Haldex ILAS III Valve Product Change Notification

Automatic

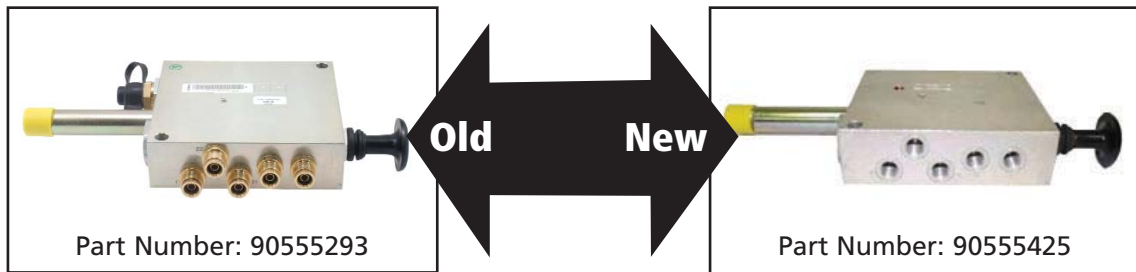
Beginning immediately, Haldex is making a running change to offer the ILAS III Valves with a 1/4" - 18 NPT threaded port design for all North American customers. The change from 3/8" Push-To-Connect (PTC) fittings will allow for universal pipe size and add opportunity for possible replacement of fittings, if necessary in the later stages of service life. Fittings will no longer be pre-installed or included with the new design.

Haldex is in the process of releasing a fitting kit that will include five each 1/4"-18 NPT, 3/8" Tube Push-To-Connect (PTC) fittings. Please note that PTC fittings should not be used in Canada due to extreme cold. Maximum torque values will be determined by the style of fitting chosen for installation; however, there should be no air leaks at the fitting joints when full system pressure is applied. Always follow the fitting manufacturer's recommendations regarding torque, sealant and lubricant.
